RE: Site Plan Approval for 140 Court Street; Portsmouth Housing Authority

We hereby submit, on behalf of the Portsmouth Housing Authority, this **Response to Comments** for consideration at your August 7 TAC Committee Meeting. The response is based on the July 31 email comments as well as comments from the July 31 TAC meeting. Comments shown below with responses in **bold text**:

WORKFORCE HOUSING DEVELOPMENT

160 COURT STREET

SITE LAYOUT PLAN

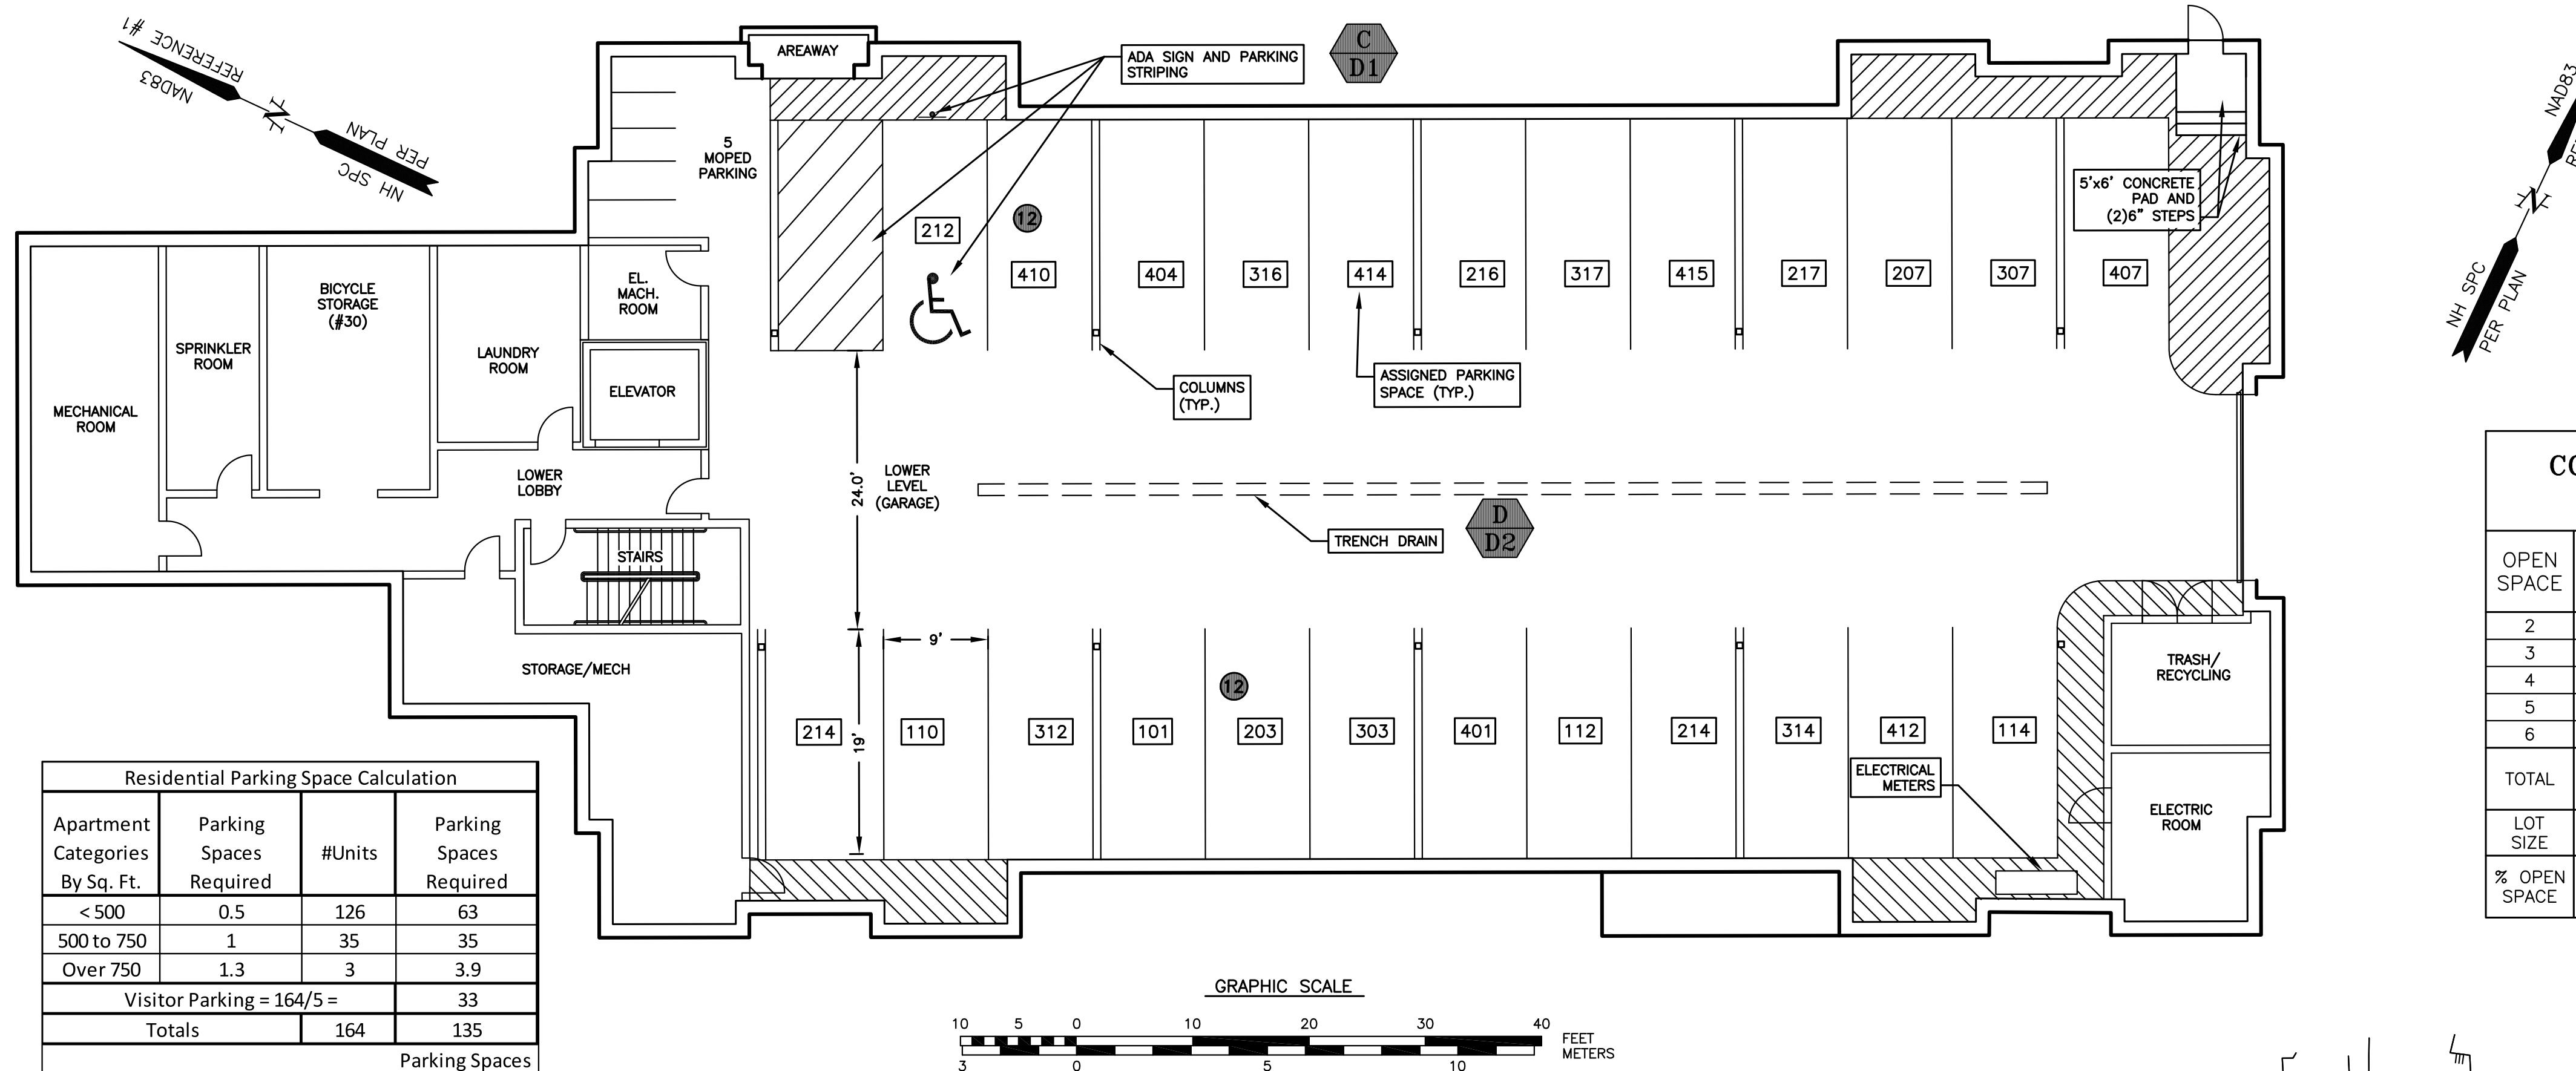
1. Sight lines at the site driveway are limited due to the fence on the abutter's property. While it does not affect the sight lines to see oncoming vehicles on Court Street, it does limit the sight lines for oncoming pedestrians on the sidewalk. The applicant should work with the abutter to relocate or modify the fence to increase the visibility for pedestrians on the sidewalk and vehicles exiting the site. This existing situation will be exacerbated with the increase in traffic using this driveway to exit the site.
The applicant is willing to request this modification; and work with the abutter if they are agreeable. See Note 9 on Sheet C3.

2. The proposed taxi/Uber parking space on Court Street is located beyond the stop line for the emergency signal for the fire station. A vehicle parked in the space would not be able to see the emergency signal when it is activated and could cause a conflict with emergency vehicles exiting or entering the fire station. I would recommend eliminating this proposed space unless the Fire Department is ok with it. **The proposed space has been eliminated – Sheet C3.**

3. The “Proposed UBER / Taxi Space” on Court Street should be eliminated. Public transit busses making a right turn from Fleet onto Court have to make a wide turn which could impact a vehicle in that parking spot. **The proposed space has been eliminated – Sheet C3.**

4. The emergency signal for the fire station is missing the required EMERGENCY SIGNAL sign. With the increase in traffic through this area due to the proposed project, the applicant should consider installing this sign to increase awareness of the purpose of the signal. **PHA will work with the Fire Department to locate the sign as requested. See Note 10 on Sheet C3.**

5. The fire station emergency signal that is currently located at the corner of Fleet Street and Court Street, should be relocated to the other side of Court Street, as the project

24. The entrance radius should be re-set at the sidewalk. **This is shown on Sheet C3.**
25. There should be a "Yield to Pedestrians" SIGN added at the entrance. **This is shown on Sheet C3.**
26. The Traffic Signal Controller may need to be relocated. **This is shown on Sheet C3.**
27. The brick pattern in Court Street should match the adjacent sidewalk, which is Herringbone. **This is noted in Note 11 on Sheet C3.**

will be closing the entrance to the parking lot and there will now be space to properly locate the signal on the right hand side of the roadway. **PHA will work with the Fire Department to locate the signal as requested. See Note 10 on Sheet C3.**

UTILITY PLAN

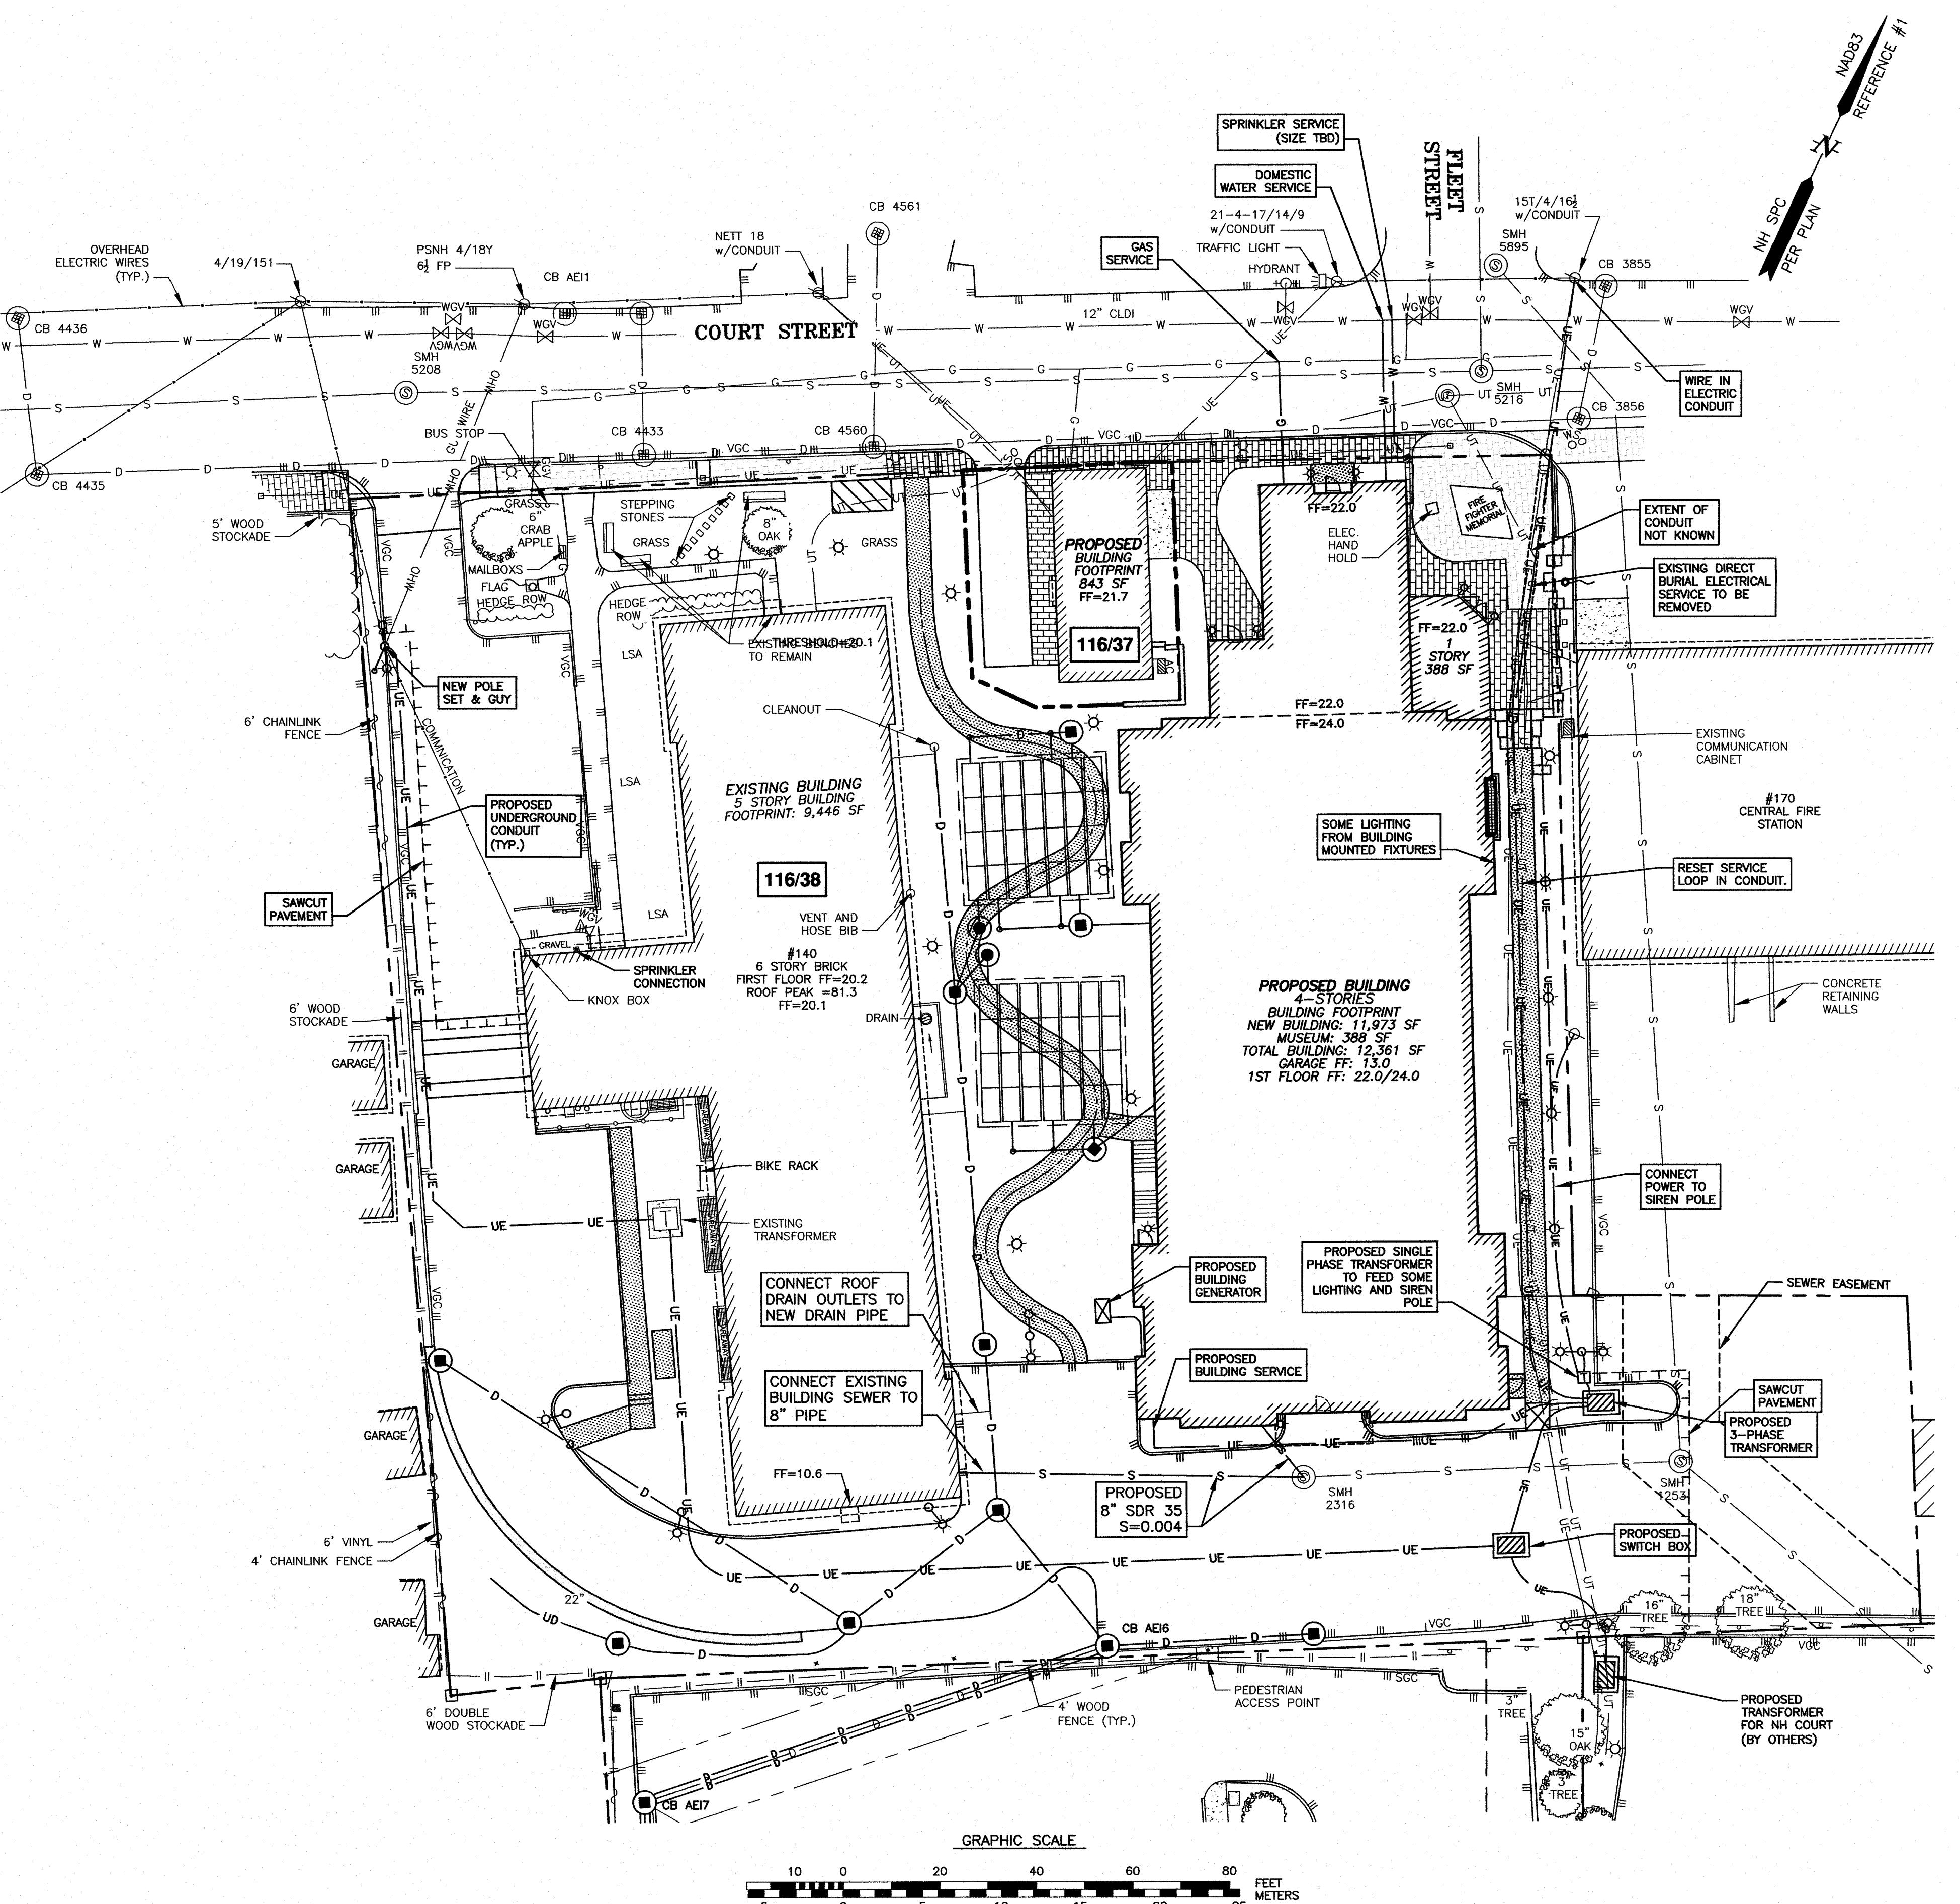
19. Sheet C5: Sewer easement (20 feet wide) needs to be granted to the City for existing sewer in southeast corner of property. **The easement has been added to Sheet C5.**

SCALE: 1'=20' FEBRUARY 2018
**DRAINAGE, GRADING
AND EROSION CONTROL
PLAN** C6

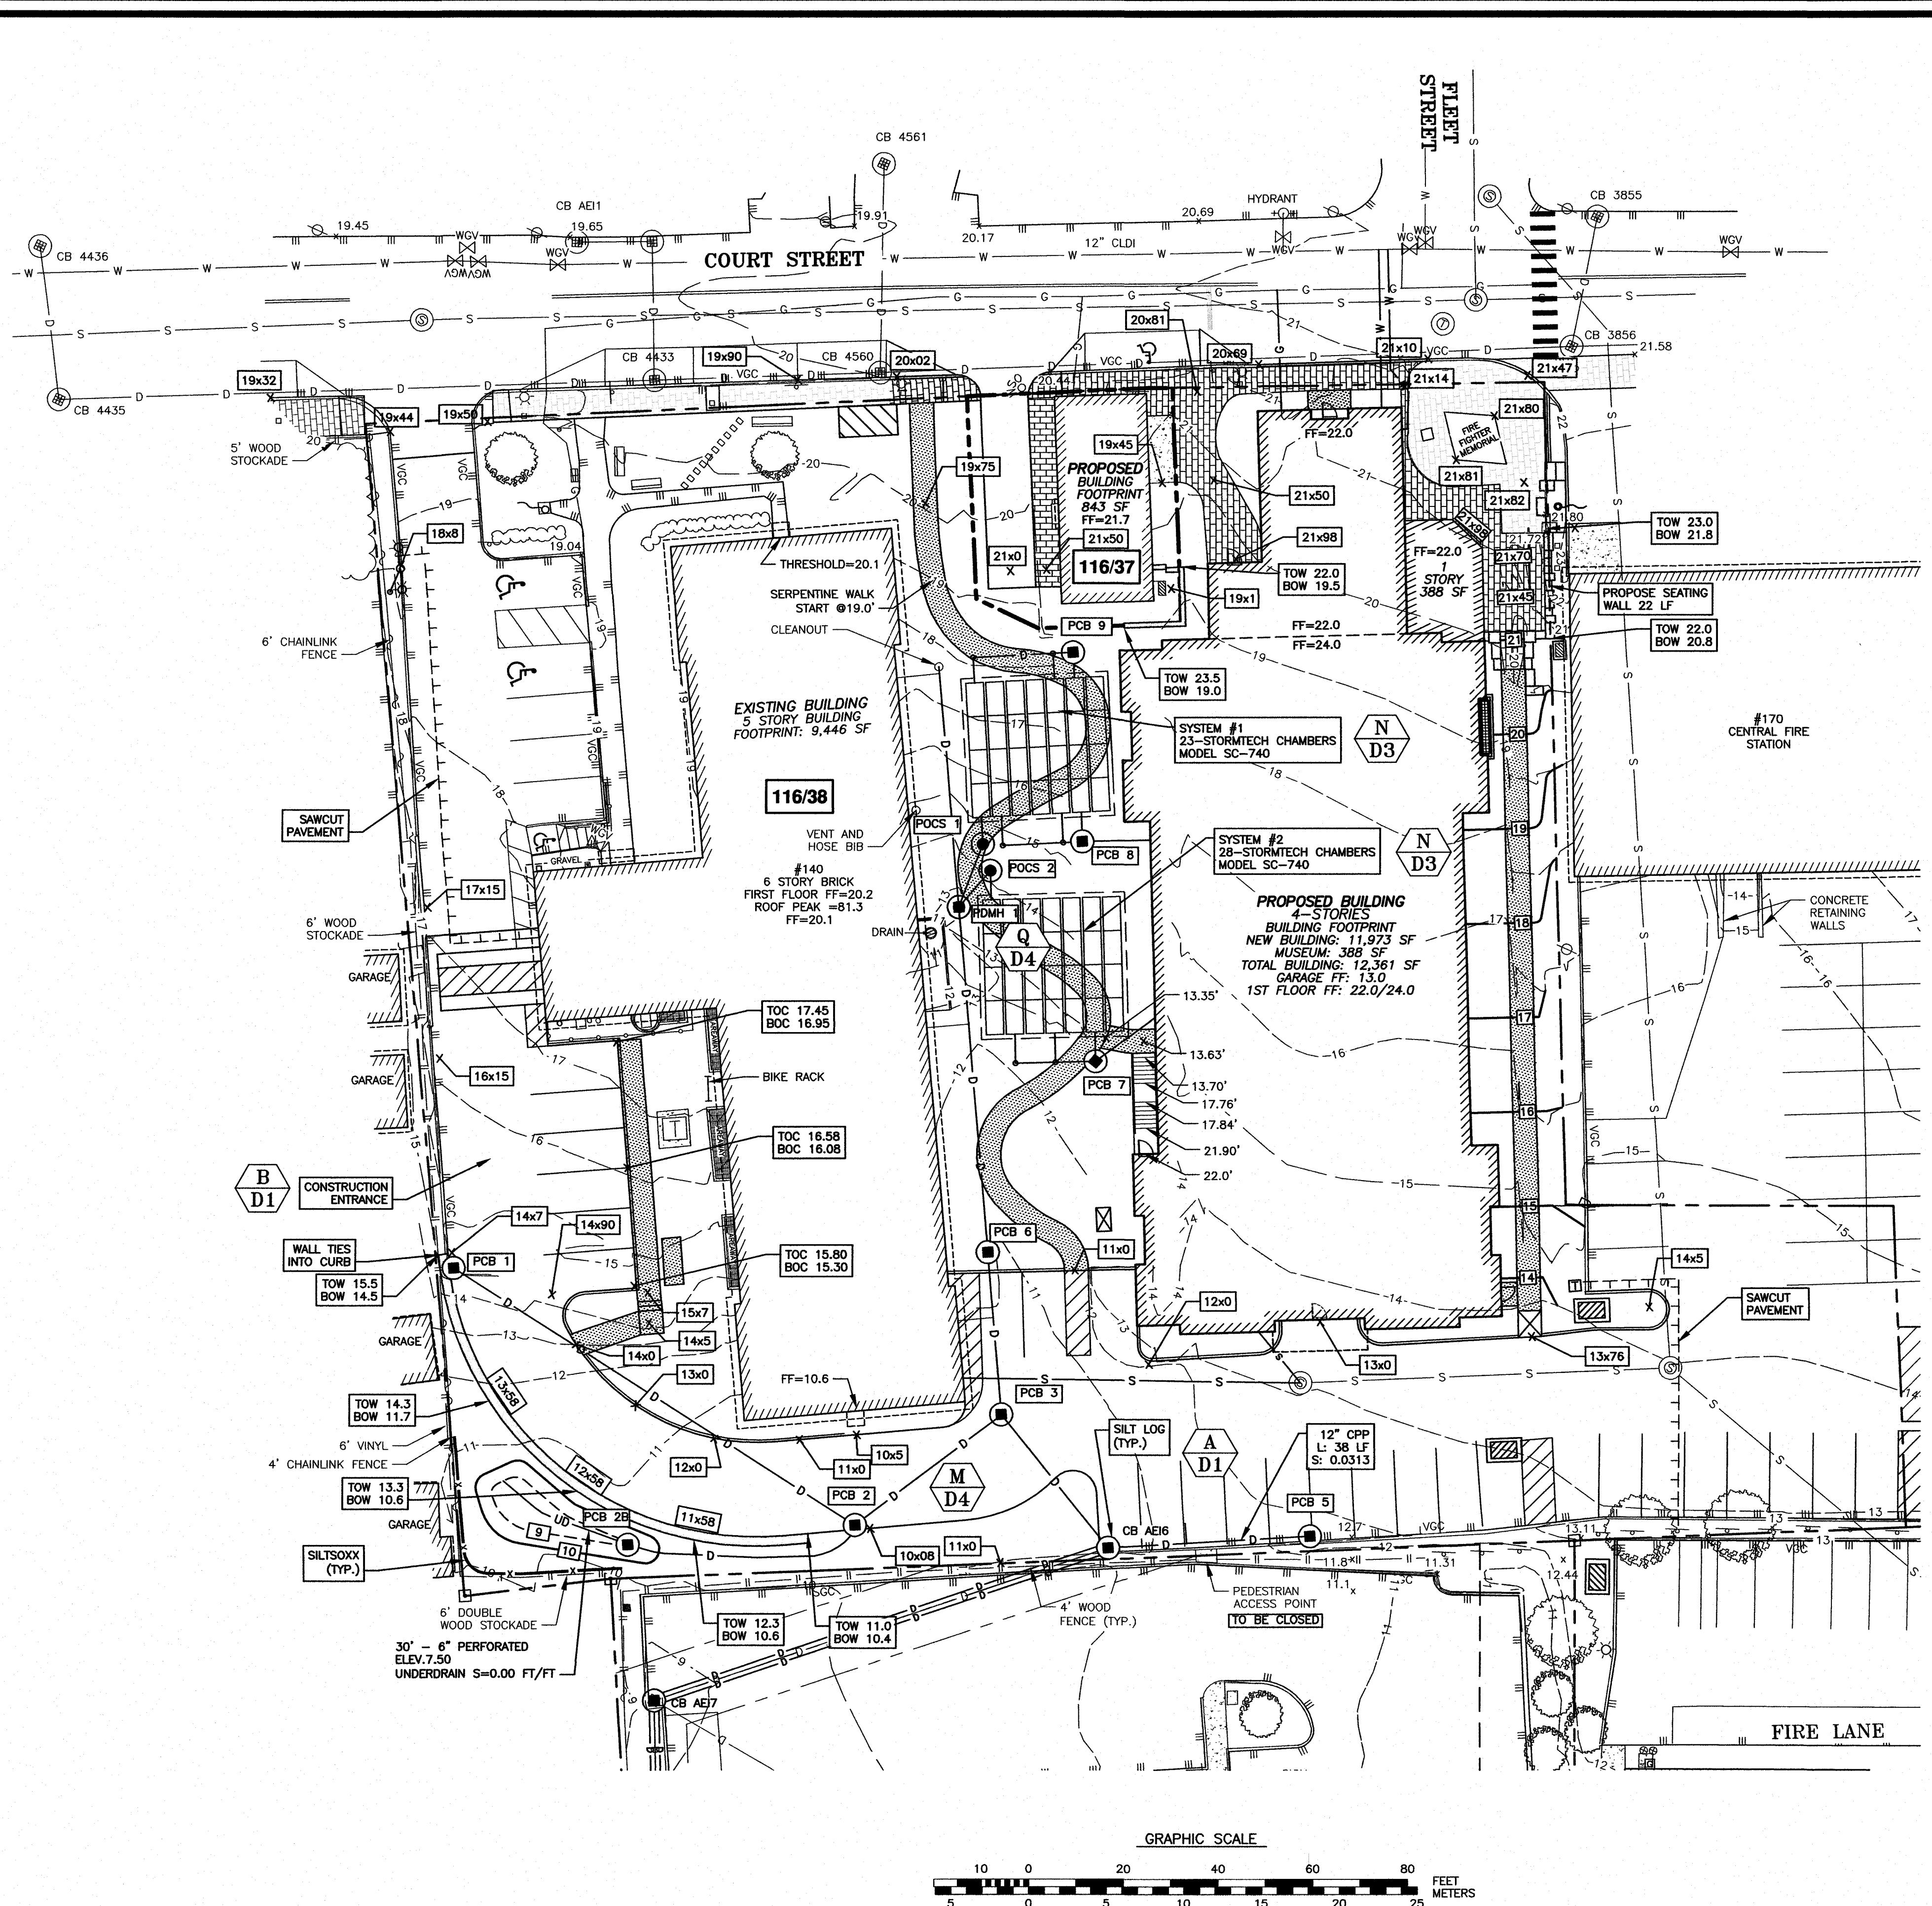
10. There may be conflicts with the proposed drainage pipes. City to be notified of any conflicts. **The plans reflect this in Note 4 on Sheet C6.**
11. Brick Sidewalk detail, there are 4.5 Bricks to the square foot. **Detail H, Note F has been revised.**
